Proposal for corrigendum to ECE/TRANS/WP.29/GRSG/2022/6

Submitted by the experts of the IWG on VRU-Proxi

Figure 4
Field of Detection

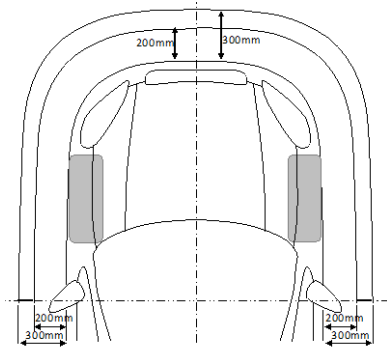
Paragraph 15.3., Figure 4 amend to replace:

Figures used in ECE/TRANS/WP.29/GRSG/2022/6 were only focused on the front area for detection. These figures shall be replaced to the figures focused on detection area all around the vehicle front and lateral side.

Figure 1
~~Figure Title~~ **Field of detection**

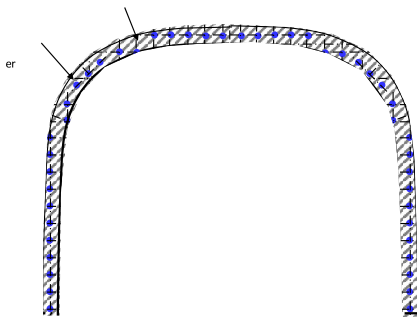
Annex 12 Paragraph 1.3.1., Figure 1 amend to read and replace:
